BUILDING DEPARTMENT
PERMIT

Permit Number: 070870

This is to certify that BLACKMER MINOTT P & SON ARNA M BLACKMER JTS/S arehas permission to New Ranch style home w/ 2 car garageAT 14 BASKET LN Lot#19

ONE AND TWO FAMILY	PLAN REVIEW	CHECKLIST		
Soil type/Presumptive Load Value (Table R401.4.1)				
Component	Submitted Plan	Findings	Revisions	Date
STRUCTURAL				
① Footing Dimensions/Depth (Table R403.1 & R403.1(1), (Section R403.1 & R403.1.4.1)	Frost wall shown @ 3'-2"			
Foundation Drainage, Fabric, Damp proofing (Section R405 & R406)	OK - noted			
Ventilation/Access (Section R408.1 & R408.3) Crawls Space ONLY	N/A			
Anchor Bolts/Straps, spacing (Section R403.1.6)	1/2" - 6' oc			
Lally Column Type (Section R407)				
② Girder & Header Spans (Table R 502.5(2))				
Built-Up Wood Center Girder Dimension/Type	NOT shown	OK	- 3-2x12's	
Sill/Band Joist Type & Dimensions	2x6 PT			
First Floor Joist Species Dimensions and Spacing (Table R502.3.1(1) & Table R502.3.1(2))	2" x 12" - 5 - 15' span 16" oc - OK			
Second Floor Joist Species Dimensions and Spacing (Table R502.3.1(1) & Table R502.3.1(2))	N/A			
Attic or additional Floor Joist Species Dimensions and Spacing (Table R802.4(1) and R802.4(

Garage stair detail

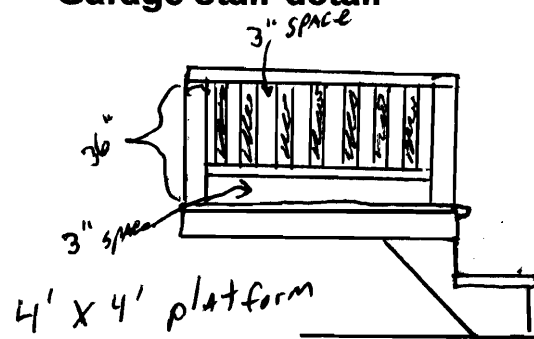
① Type of Heating System	not shown	— OK
② Means of Egress (Sec R311 & R312) Basement 1 Number of Stairways 1 Interior 2 Exterior 0 Treads and Risers 10" T + 7 7/16" R. (Section R311.5.3) Width (Section R311.5.1) not shown - 36" - OK Headroom (Section R311.5.2) 7'-0" Guardrails and Handrails — OK see detail (Section R312 & R311.5.6 - R311.5.6.3)		
③ Smoke Detectors (Section R313) Location and type/Interconnected	not shown	— OK
④ Draftstopping (Section R502.12) and Fireblocking (Section (R602.8) Dwelling Unit Separation (Section R317) and IBC - 2003 (Section 1207)	N/A	2x6 Framing
⑤ Deck Construction (Section R502.2.1)	Need garage stair detail	— OK

Total rise = 15 1/2"

Steps: 7 3/4" rise

10" run w/ 3/4" nose

36" wide

Exhibit "A"

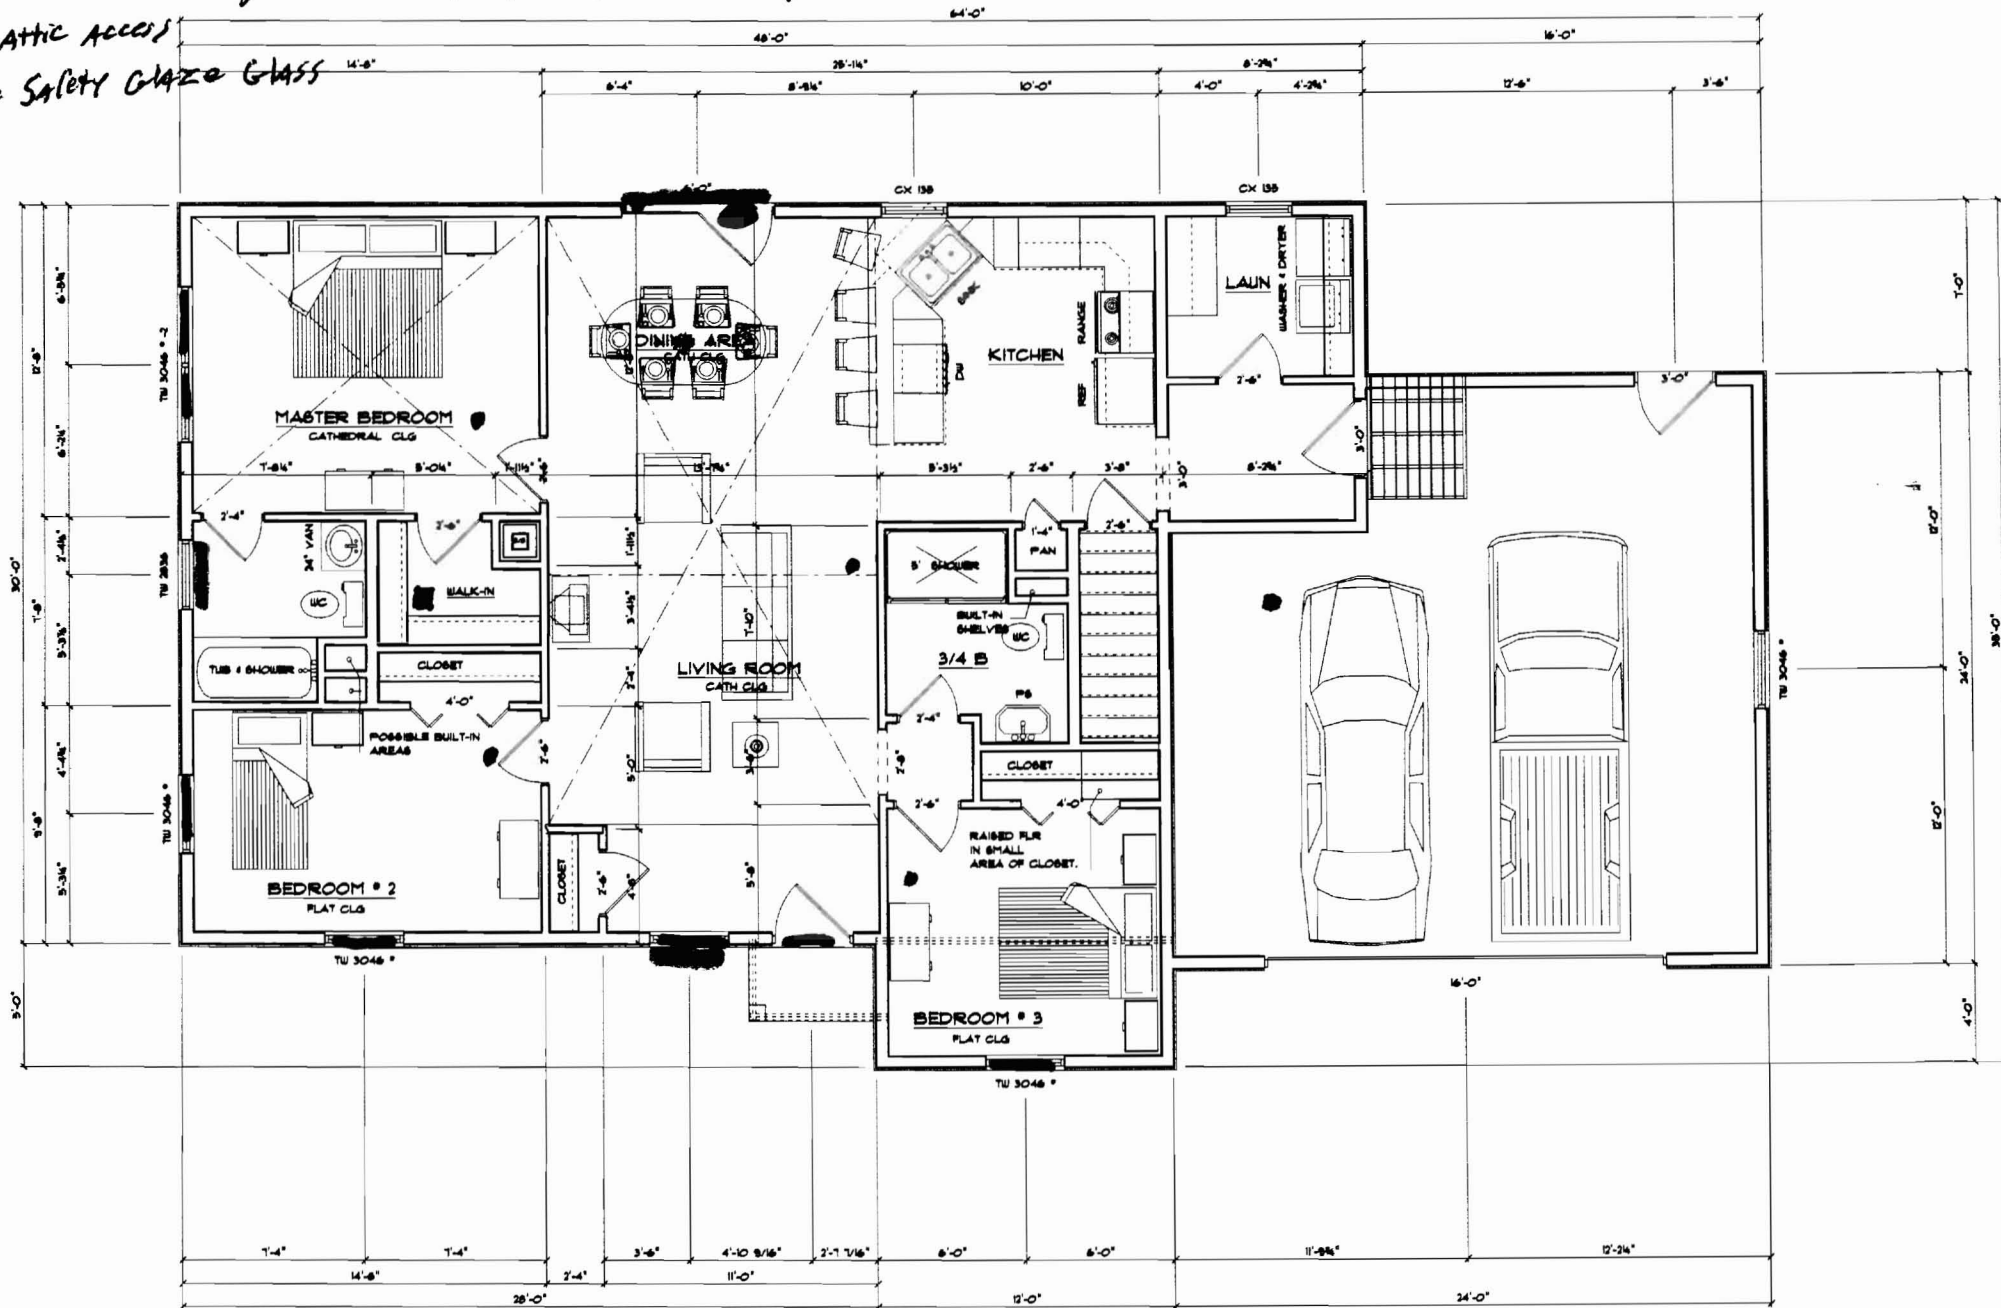
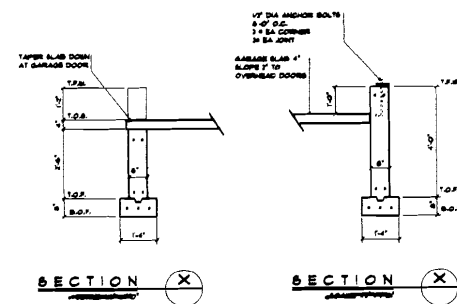
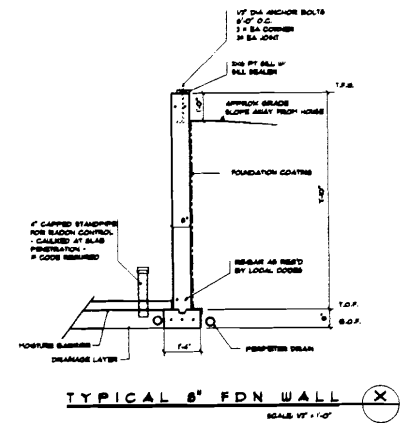
1 Garage frost wall	section shown is labeled 2' 6" + 4" + 1" 2" = 4' 0" total frost wall
2 Wood center girder	3 - 2" x 12"
3 Fire Separation	
4 Emergency Escape/rescue openings	noted on drawing "Exhibit A"
5 Safety glazing	noted on drawing "ExhibitA"
6 Attic Access	noted on drawing "ExhibitA"
7 Chimney Clearances	Stainless steel min. 2" from combustible materials, enclosed in living space Fire stop / block with sheet metal between floors & 1" rockwool if needed
8 Header Schedule	Exterior wall headers =(3) - 2"x10" w/a 1" foam insulation board sandwiched Interior headers shall be (2) - 2"x8" w/ 1 layer 1/2" plywood sandwiched
10 Type of heating system	Oil fired boiler, forced hot water through baseboard
11 Stair width	36"
12 Smoke detectors	noted on drawing "ExhibitA"
13 Garage stair detail	See below
14 Bottom rail of guard	6" diameter max triangle opening

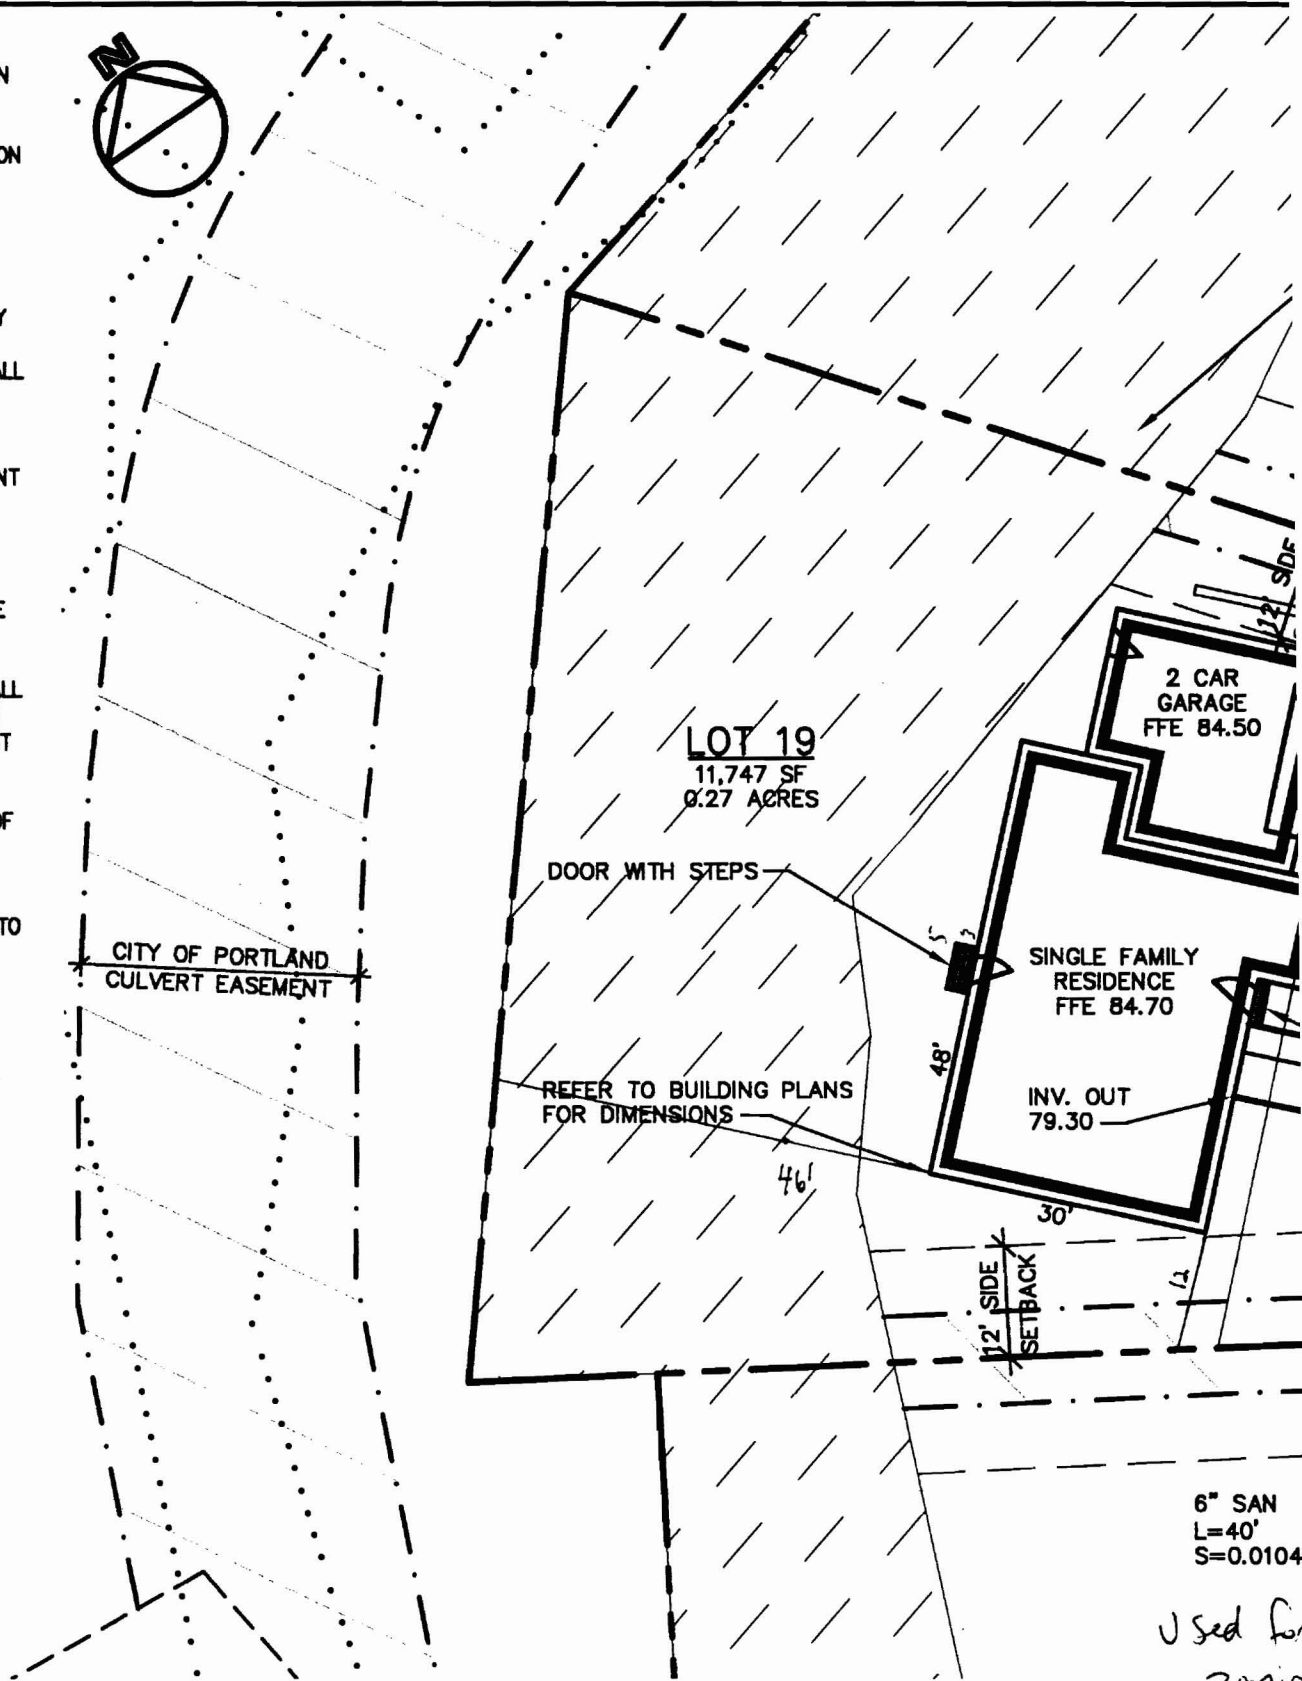
⑩	Type of Heating System	Not shown	
	Means of Egress (Sec R311 & R312) Basement 1 Number of Stairways 1 Interior 2 Exterior 0 Treads and Risers 10" T + 7 7/16" R. (Section R311.5.3)		
⑪	Width (Section R311.5.1) Not shown Headroom (Section R311.5.2) 7'-0" Guardrails and Handrails — OK see detail (Section R312 & R311.5.6 - R311.5.6.3)		
⑫	Smoke Detectors (Section R313) Location and type/Interconnected	Not shown	
	Draftstopping (Section R502.12) and Fireblocking (Section R602.8) Dwelling Unit Separation (Section R317) and IBC - 2003 (Section 1207)	N/A	
⑬	Deck Construction (Section R502.2.1)	Need garage stair detail

⑭ Bottom rail of guard - 6" diam max triangular opening

Drawing Name:	Lot 19 Grading Plan
Project:	RIVERWALK

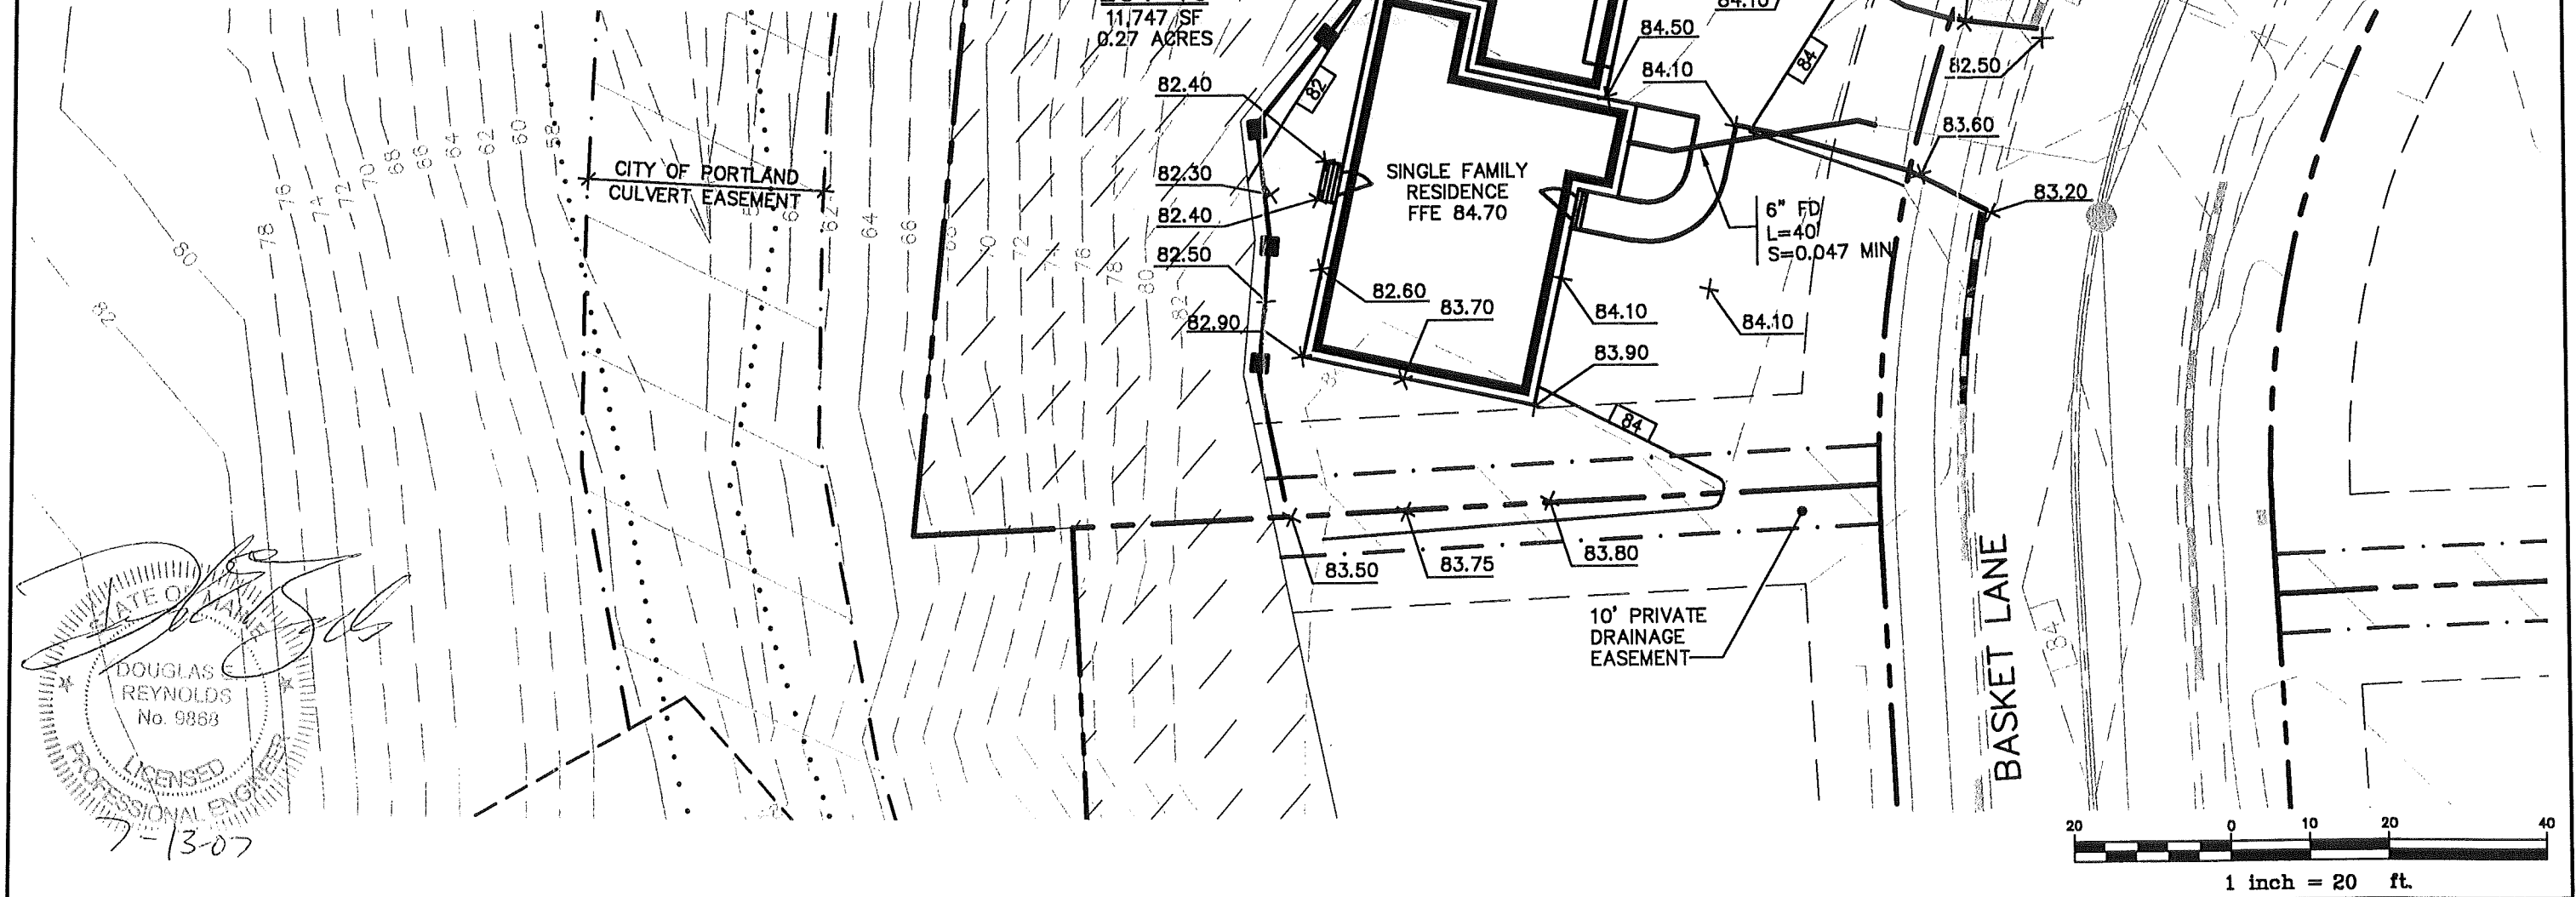
- 7) The note on sheet 3 of the approved single family site plan shall be followed exactly as written, ie hiring licensed professionals to perform the required layout, inspections, and written confirmations.

7/24/2007-amachado: Left message for Scott Crepeau. Bulkhead is not shown on site plan. Scott called me back. Said that not putting in bulk head. Will fax me something in writing.

The drafted house prints from the lumber yard show a bulkhead on the house. However the site plan does not show a bulkhead. **There will not be a bulkhead on this house.** The lumber yard took the liberty of showing a bulkhead on the house prints in case the home owner wanted it, without having to take the time draw it in again.
